UNITED STATES
NUCLEAR REGULATORY COMMISSION

APPLICANT: Combustion Engineering, Inc. (ABB-CE)
PROJECT: CE SYSTEM 80+
SUBJECT: MEETING ON APRIL 30, 1992, REGARDING THE MODIFIED ELECTRICAL
DISTRIBUTION SYSTEM FOR SYSTEM 80+

ATTENDEE LIST
ELECTRICAL DISTRIBUTION
APRIL 30, 1992

ELECTRICAL DISTRIBUTION SYSTEM PROPOSAL

Figure 11.2-1 PWR Electrical System Configuration Page 11.2-5

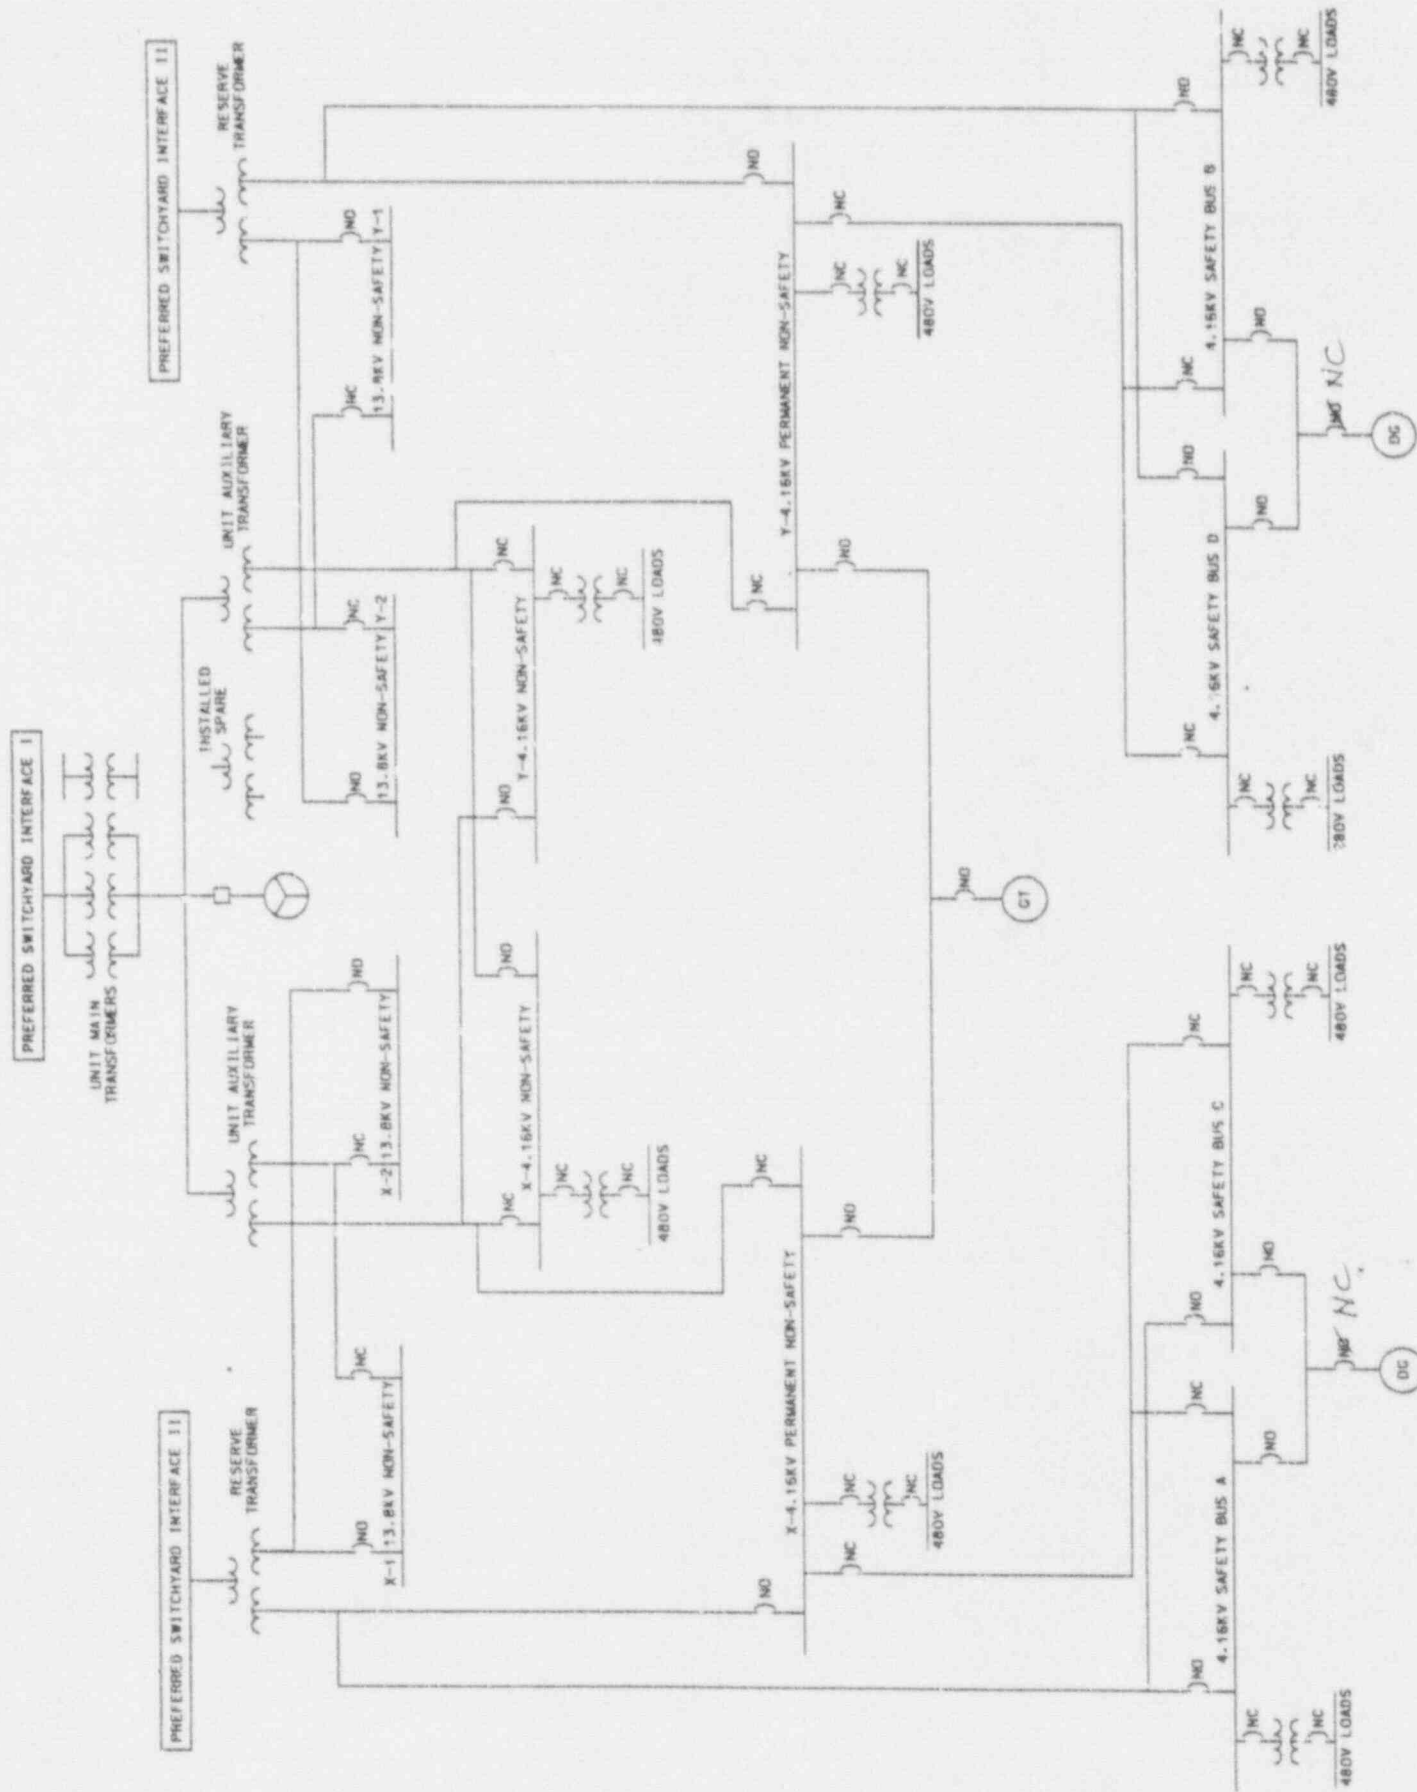
ABB-CE stated that the modified distribution system design would be submitted by May 8, 1992. This would include new drawings and marked-up pages for CESSAR-DC. The switchyard designs shown are conceptual designs for an interface requirement. The Electric Power Research Institute (EPRI) Design Requirements Document requires the feed to the safety busses to be normally from the unit auxiliary transformer and fast transfer to the reserve transformers for safety buses. The diesel generator is connected to the safety buses through two breakers in series. The diesel generator output breakers are manual and normally closed. The drawing in Enclosure 2 was corrected at the meeting to designate these breakers as normally closed.
